Shearon Harris Nuclear Power Plant, Unit 1
Docket No. 50-400 / Renewed License No. NPF-63

Subject: Response to NRC Request for Additional Information (RAI) Regarding Application to Adopt 10 CFR 50.69, "Risk-Informed Categorization and Treatment of Structures, Systems, and Components (SSCs) for Nuclear Power Reactors"

Response to NRC Request for Additional Information (RAI) Regarding Application to Adopt 10
CFR 50.69, "Risk-Informed Categorization and Treatment of Structures, Systems, and
Components (SSCs) for Nuclear Power Reactors"

Figure 5-6
OTHER EXTERNAL HAZARDS

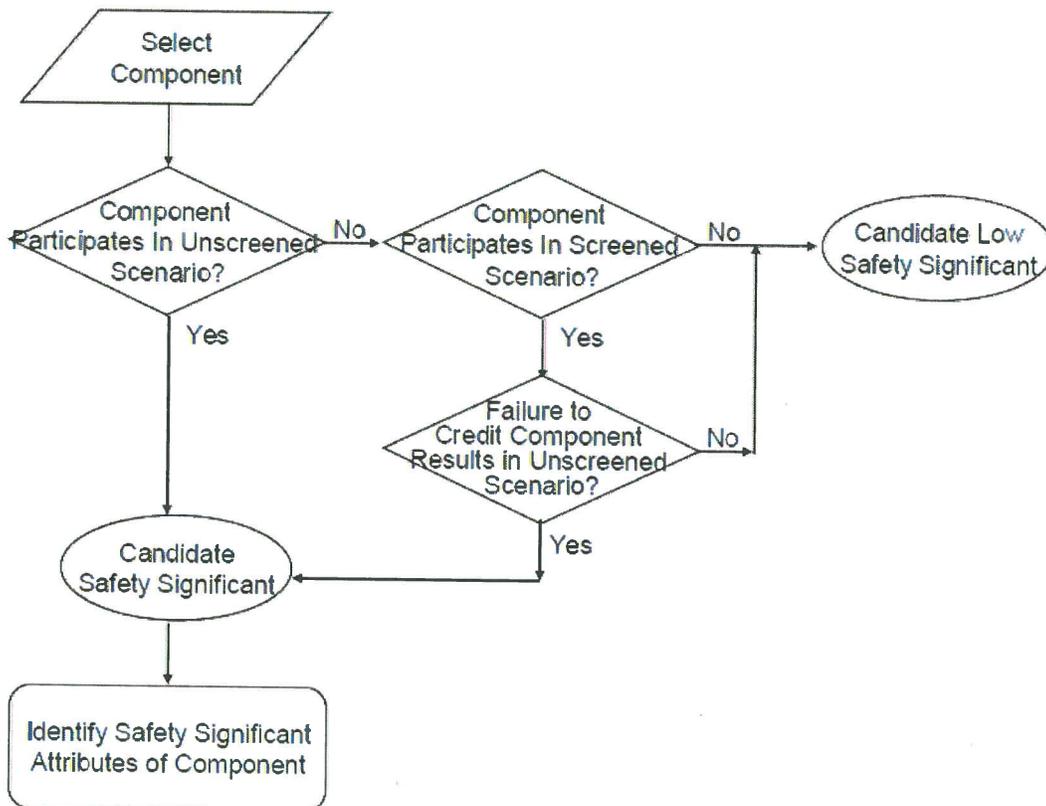
As part of the categorization assessment of other external hazard risk, an evaluation is performed to determine if there are components being categorized that participate in screened scenarios and whose failure would result in an unscreened scenario. Consistent with the flow chart in Figure 5-6 in Section 5.4 of NEI 00-04, these components would be considered HSS. All remaining hazards were screened from applicability and considered insignificant for every SSC and, therefore, will not be considered during the categorization process.

The last sentence implies that the assessment has been completed and concludes that all other external hazards will never need evaluation during categorization. The IPEEE screening process did not include the additional step illustrated in Figure 5-6 in Section 5.4 of NEI 00-04. Figure 5-6 and its associated text states that an evaluation is performed to determine if there are components being categorized that participate in screened external event scenarios whose failure would result in an unscreened scenario. Clarify how the screening criteria in Attachment 5, Progressive Screening Approach for Addressing External Hazards, satisfy the guidelines that HSS will be assigned to SSCs whose failure would cause a screened external event scenario to become unscreened.

Duke Energy Response to PRA RAI 09:

The screening criteria in Attachment 5 of the LAR were used to determine those external hazards listed in Attachment 4 of the LAR requiring a PRA model for this application and those screened from needing a PRA model. The LAR Attachment 5 denotes the screening criteria that determines “screened scenarios” versus “un-screened scenarios”.

Per NEI 00-04 the external hazard assessment is required for each SSC categorization. As such, each SSC being categorized will be assessed in accordance with NEI 00-04 Figure 5-6 for the external hazards listed in Attachment 4 of the LAR. If the failure of the SSC results in the screening criterion from Attachment 5 not being met, then the scenario would become unscreened and the SSC would become candidate High Safety Significant. NEI 00-04 Figure 5-6 is shown below for reference.
